**Seattle
Design
Commission**

MINUTES OF THE MEETING

15 January 2004

Projects Reviewed

Harborview Medical Center View of Skybridge looking North

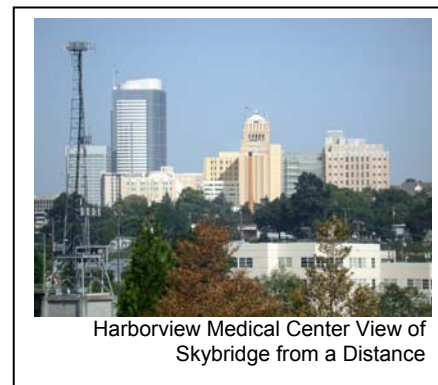
- Appreciates the change to the top of the bridge. Questions if the rest of the bridge is hanging from the truss.
 - Proponents stated that the bridge structure is hanging from the truss.

- Would like the exterior of the bridge to express the fact that it is hanging.
 - Proponents noted that the structure does read through from floor to floor.

- Questions what is happening on the roof level. Wonders if that space is occupy-able.
 - Proponents explained that the roof space is not occupy-able. They noted that the glass from the façade of the bridge extends in front of one side of the truss.

called "the Oval" is the closest to the master plan scheme. This scheme is the most passive of the three concepts. It includes:

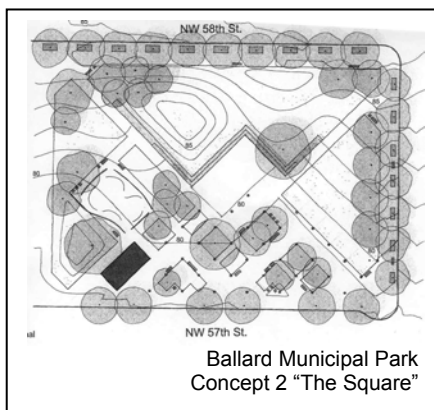
- Feels there is an opportunity to have more complexity of form.
- Is concerned that the first scheme is just a pass-through space.
- Remarks that the question should not be “why should there be a skate-bowl?”, but “why shouldn’t there be a skate-bowl?”.

The second concept "the Square" has the following features:

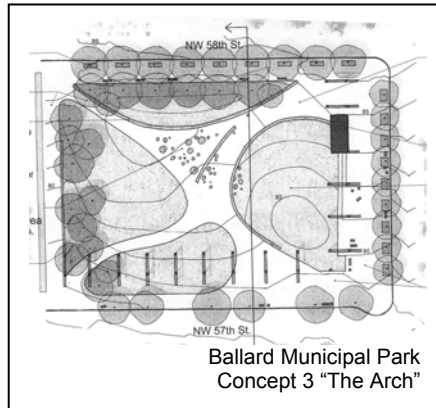
The community was concerned that this scheme was too angular, and the designers agree.

- Appreciates the presentation and that the park appeals to multiple generations. Thinks that concept 2 works well in terms of multi-generation appeal. Urges the designer to continue considering grittiness and craft. Suggests that the designer look at the work of San Francisco artist Bary McGee, who does graffiti art and urban art.
